CCK-2591.20-1-24
UK - Scovell Hall BP#01
ADDENDUM #2
02/27/2024

RENEW/MODERNIZE FACILITIES
SCOVELL HALL
University of Kentucky
Lexington, Kentucky

From: JRA Architects
3225 Summit Square Place, Suite 200
Lexington, KY 40509

1 / E-410 LEVEL 1 OVERALL TECHNOLOGY PLAN
1/8" = 1'-0"

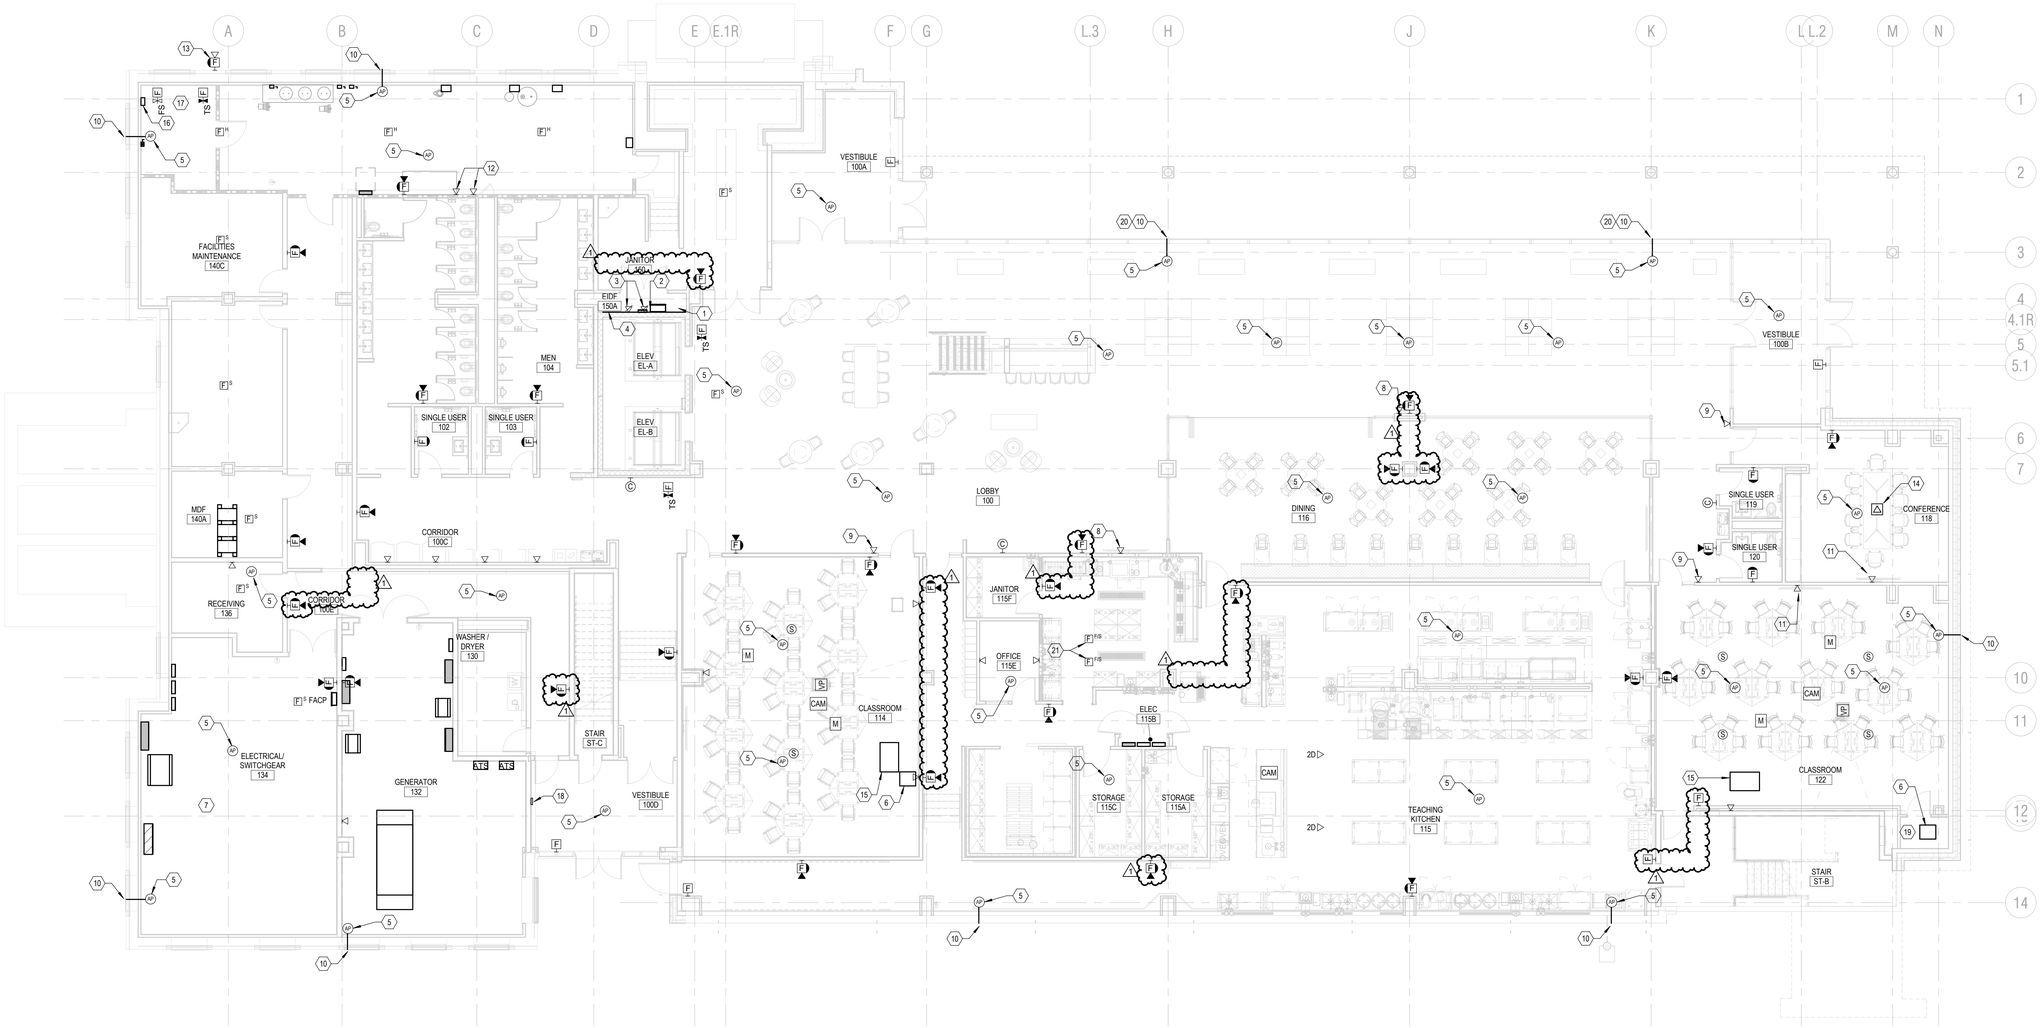
ITEM NO. 1.11
The following attached drawing sheets have been revised and should replace those issued for bid:
E-410 Level 1 Low Voltage Plans

FOUNDATION PLAN AND PARTIAL SECOND FLOOR FRAMING PLAN

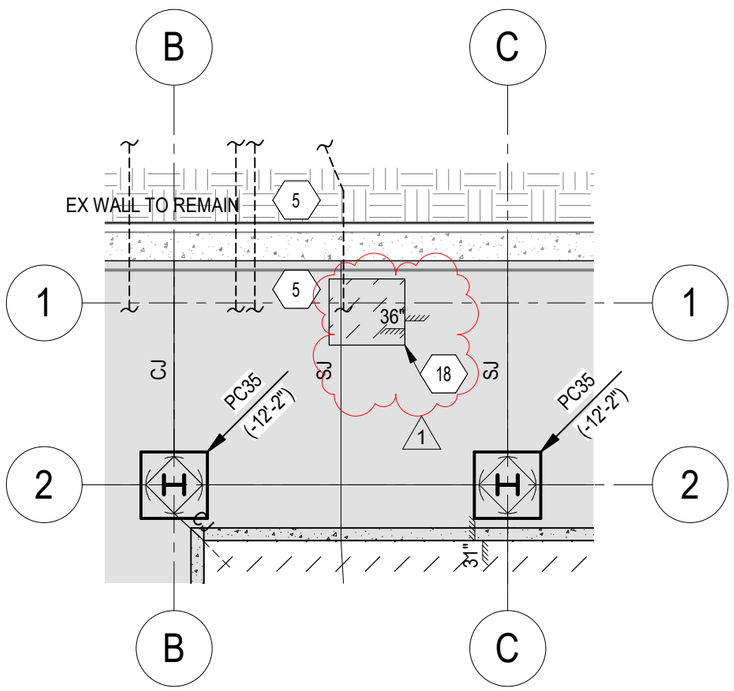
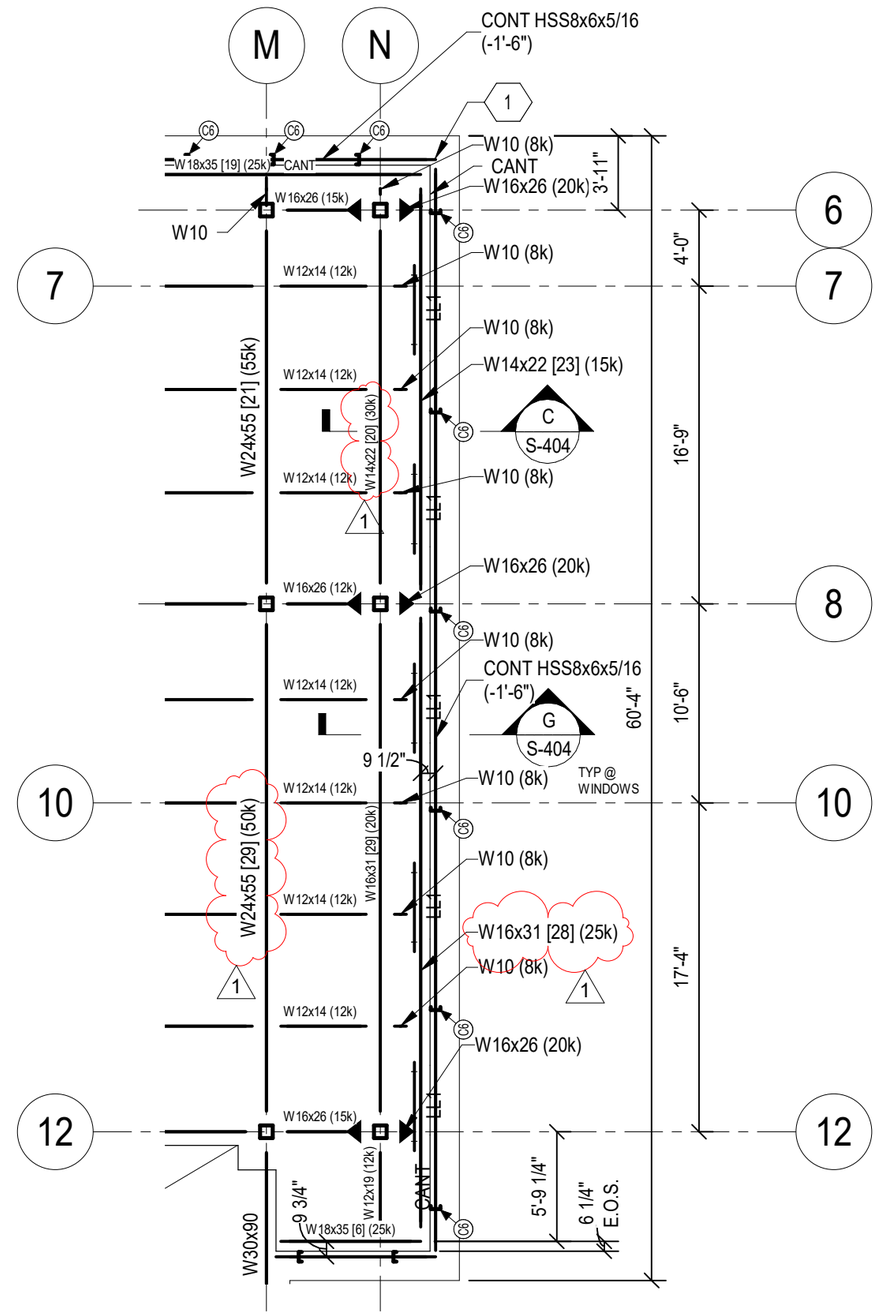
ITEM NO. 1.13
Reference Drawings S-201 and attachment SK-101:

a. Added a steam pit/sump pit at the first-floor mechanical room to match MEP drawings.
b. Added tag note #18 to note the steam pit dimensions in coordination with the MEP
c. drawing M-400 keynote #4

ITEM NO. 1.14
Reference Drawings S-202 and attachment SK-101:

a. At grid M between grids 8 and 12: changed W21x55 to be W24x55.
b. At outermost steel beam parallel to grid N between grids 8 and 12: changed W18x35 to be W16x31.
c. At grid N between grids 6 and 8: changed W16x31 to be W14x22.

PARTIAL THIRD FLOOR FRAMING PLAN

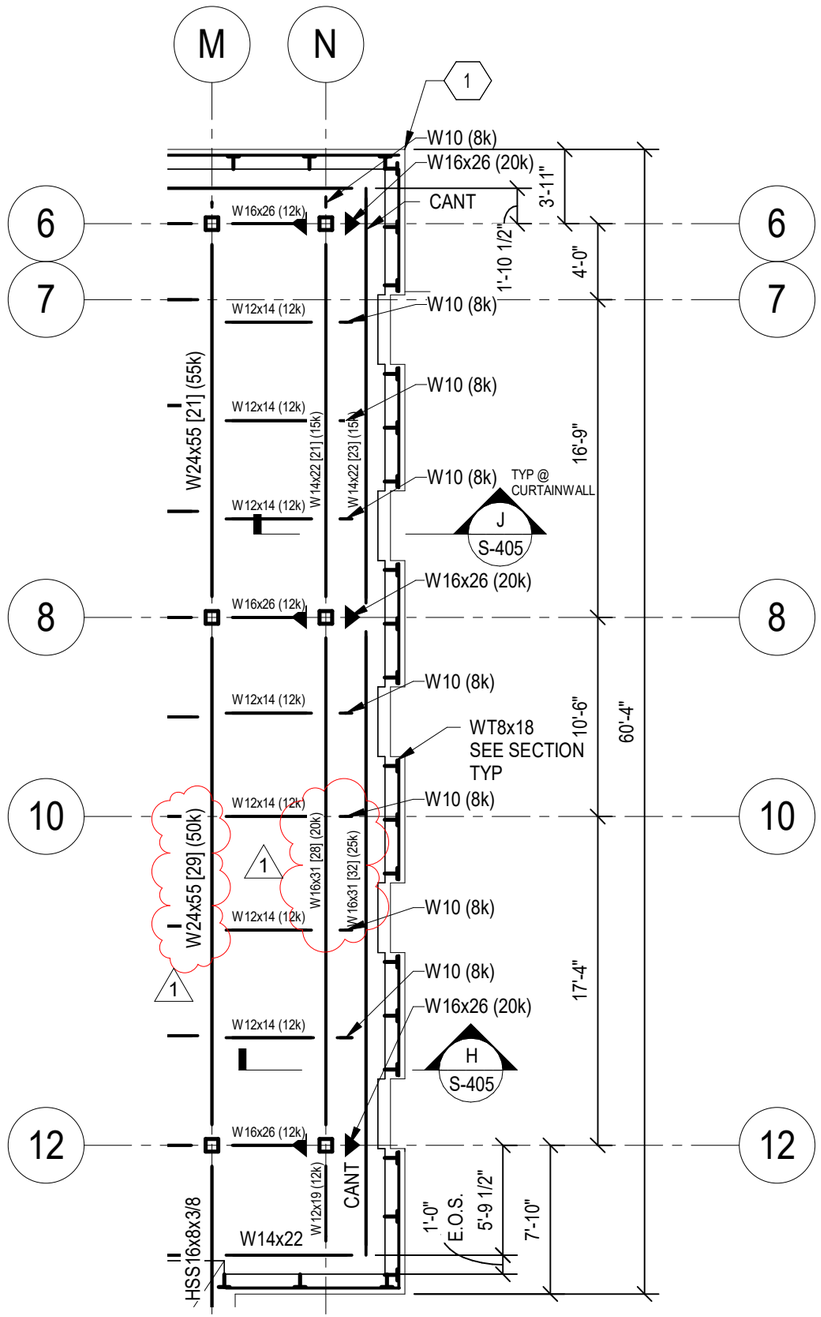
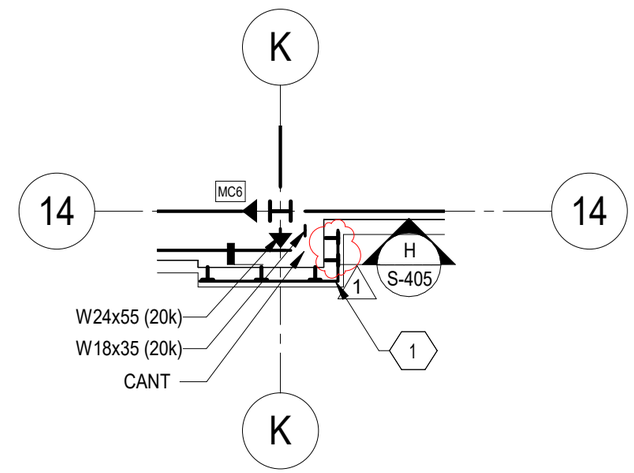
ITEM NO. 1.15
Reference Drawings S-203 and attachment SK-102:

a. Updated framing member sizes on the Third Floor Framing Plan as follows:
    a. At grid M between grids 8 and 12: changed W21x55 to be W24x55.
    b. At grid N between grids 8 and 12: changed W24x76 beam to be W16x31.
    c. At outermost steel beam parallel to grid N between grids 8 and 12: changed W18x40 to be W16x31.
b. Corrected orientation of WT8x18 miscellaneous steel members shown on plan as follows:
    a. Adjacent to column K-14: rotated (2) WT8x18 members 180° to match correct graphical orientation on plan for brick façade support.

PARTIAL FOURTH FLOOR FRAMING PLAN

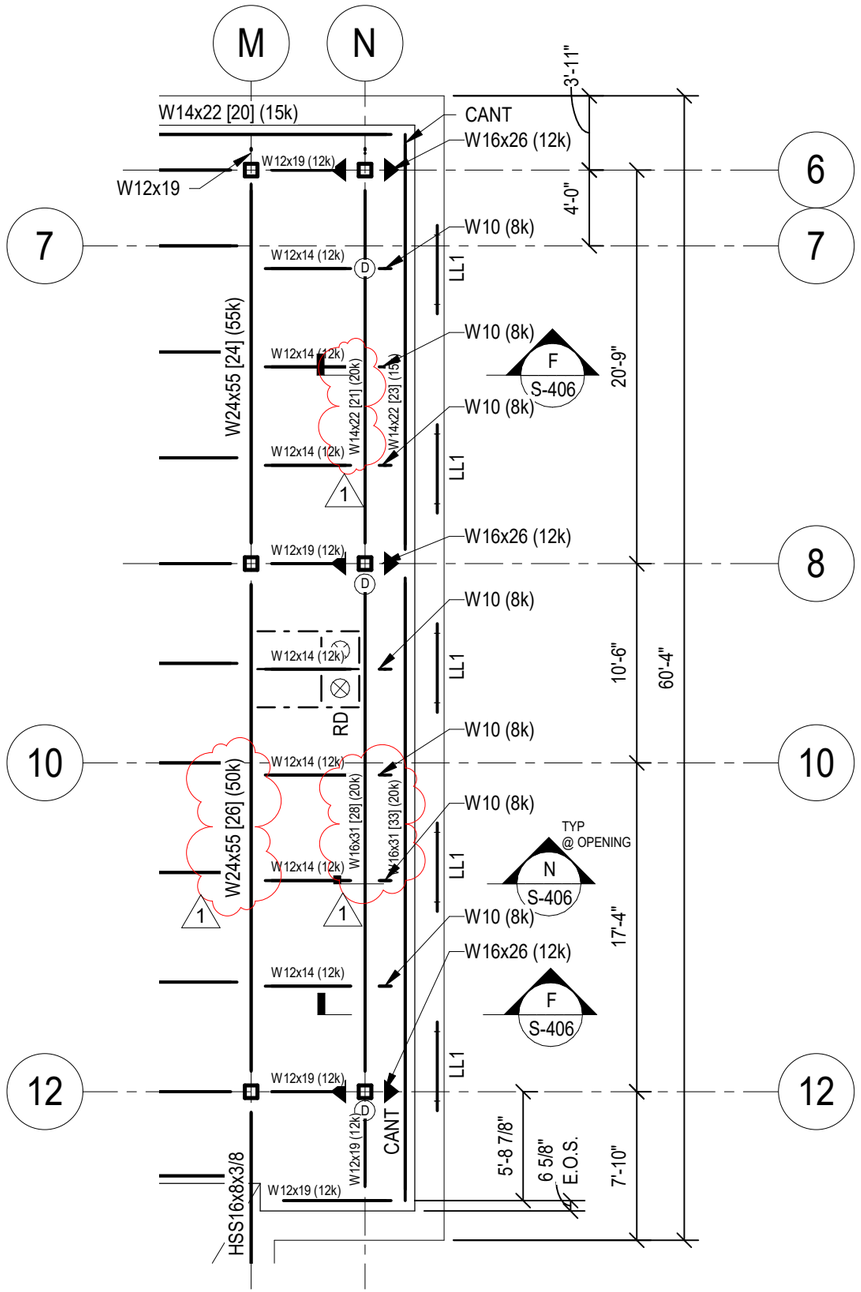
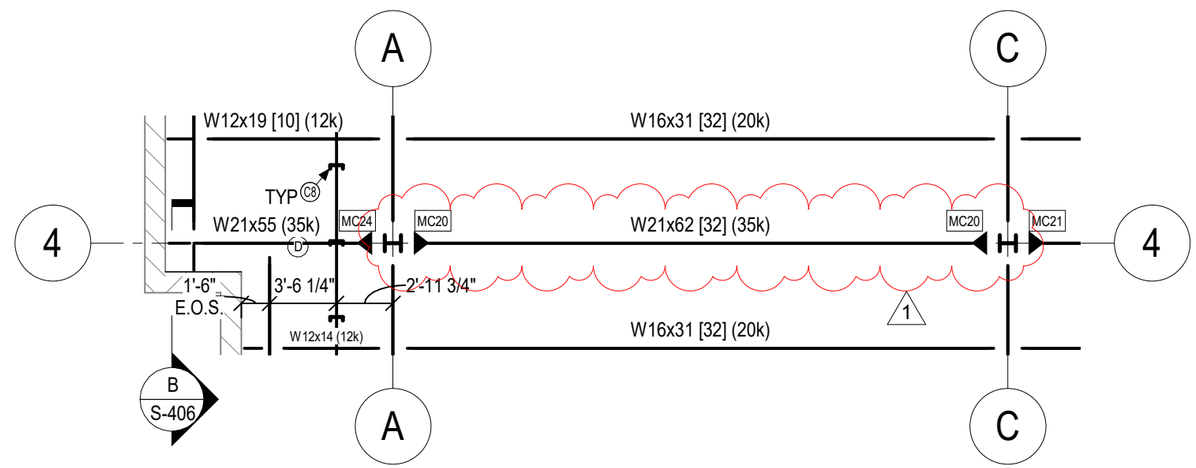
ITEM NO. 1.16
Reference Drawings S-204 and attachment SK-103:

a. Updated framing member sizes on the Fourth Floor Framing Plan as follows:
    a. At grid M between grids 8 and 12: changed W21x55 to be W24x55.
    b. At outermost steel beam parallel to grid N between grids 8 and 12: changed W16x26 to be W16x31.
    c. At grid N between grids 6 and 8: changed W16x31 to be W14x22.
    d. At grid 4 between grids A and C: changed W21x55 to be W21x62. Also changed moment connection tags from MC24 to MC20 at each end of W21x62 beam.

PARTIAL ROOF FRAMING PLAN

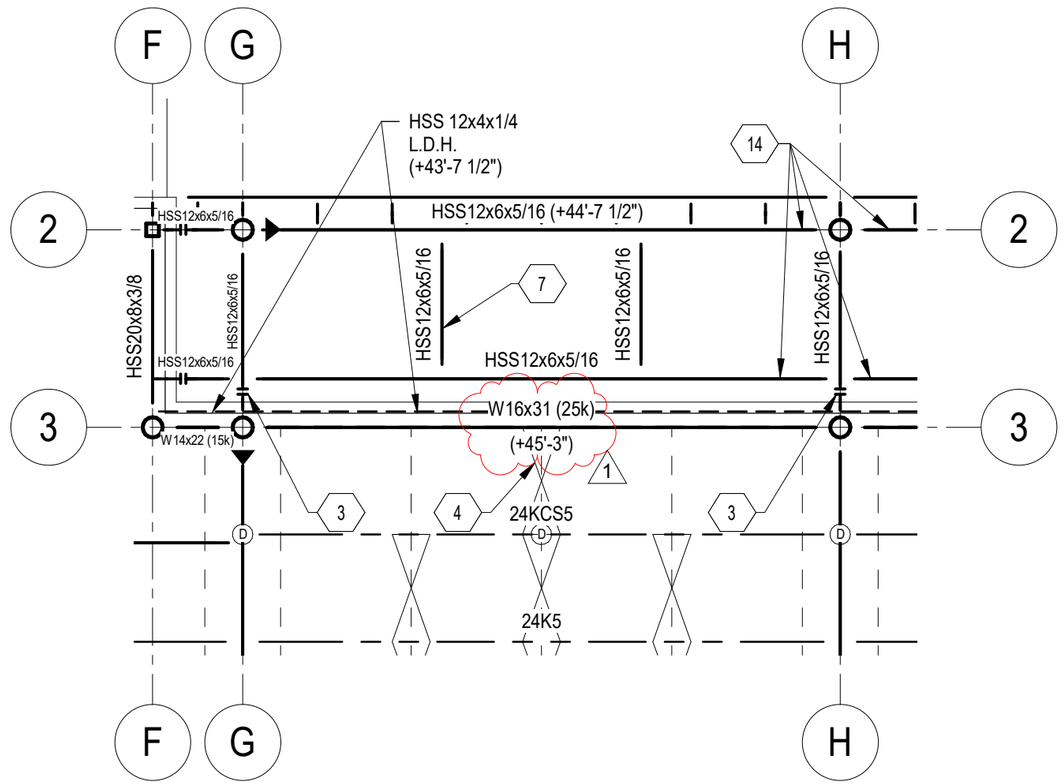
ITEM NO. 1.17
Reference Drawings S-205 and attachment SK-104:

a. Corrected graphical issue with beam framing tags at grid 3 between grids G and H:
    a. Beam tag “CONT HSS12x4x1/4” was shown over top of beam tag W16x31 at this location. Deleted HSS beam tag since beam is already tagged as “HSS12X4X1/4 L.D.H. (+43’-7 1/2”)” on plan.
